Nomination Form
Anadromous Waters Catalog

Anadromous Waters Catalog Number of Waterway 106-44-10155

106-44-10155 Route Correction

Figure 1. 106-44-10155 Route Correction map.

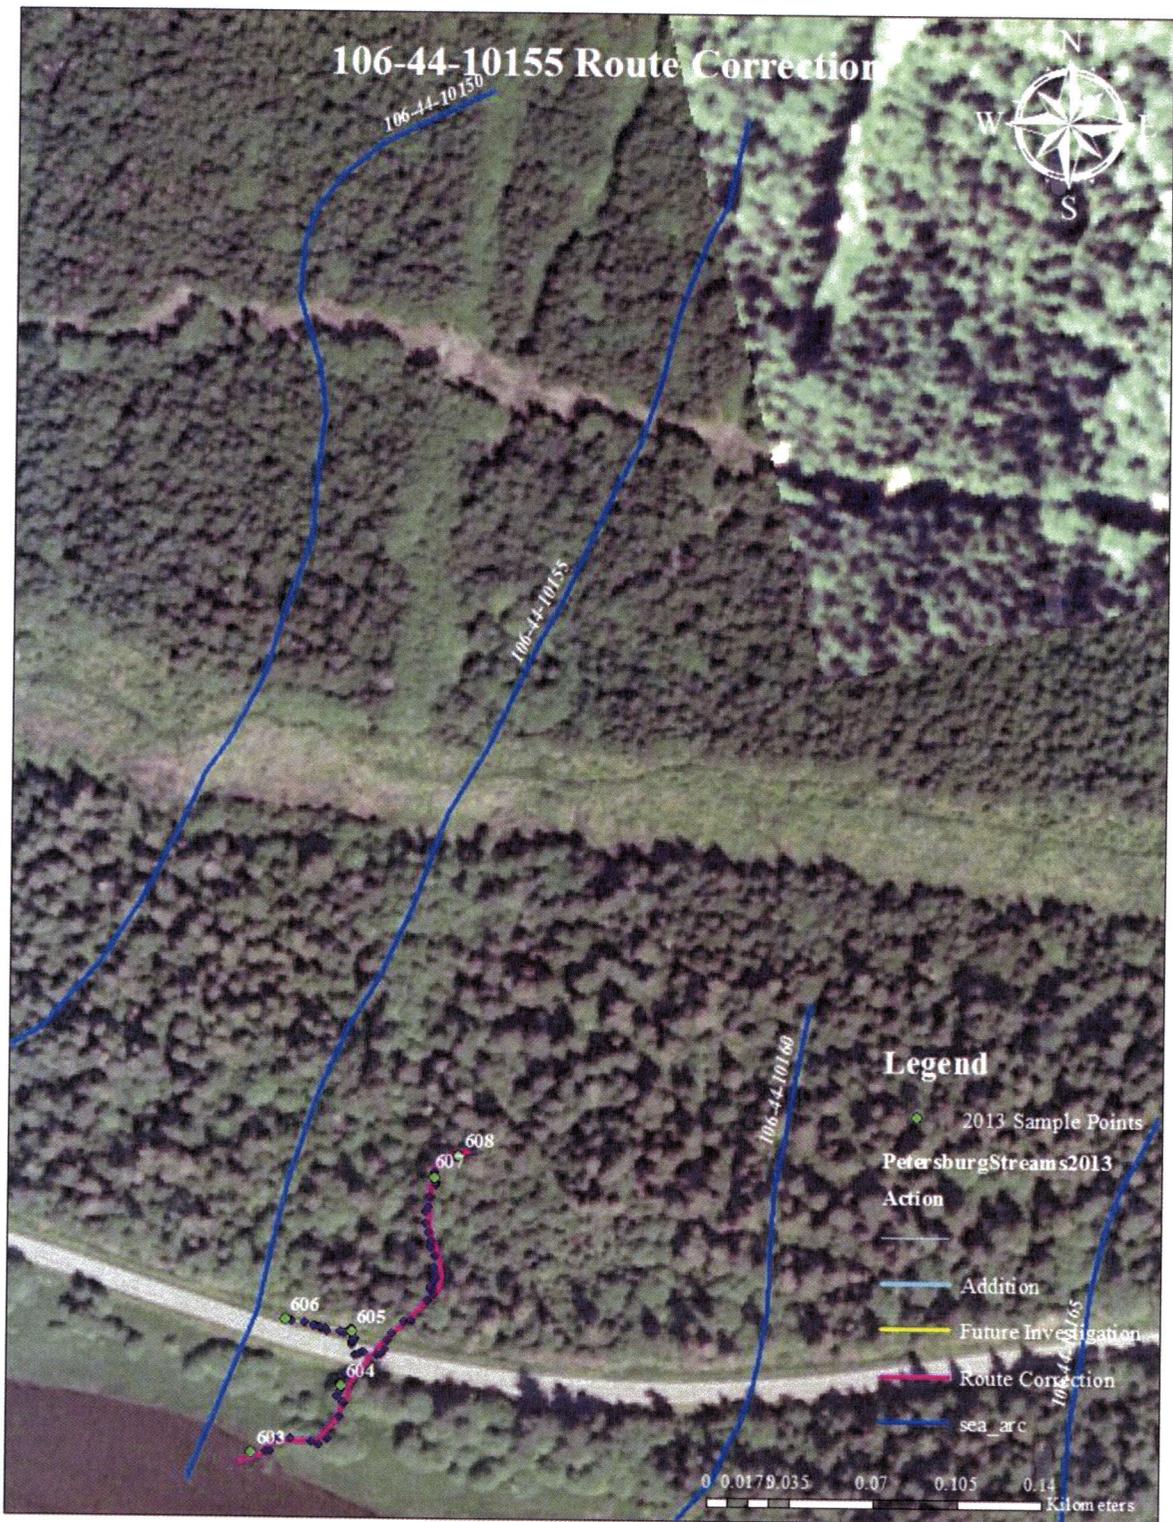
Findings: This stream's route differs from that illustrated in the AWC.

revise hydro for 106-44-10155, add coho salmon rearing,
use quinn\PetersburgStreams2013.shp for hydro

Recommendations: Update this stream's course to reflect its upper and lower limit in the AWC.
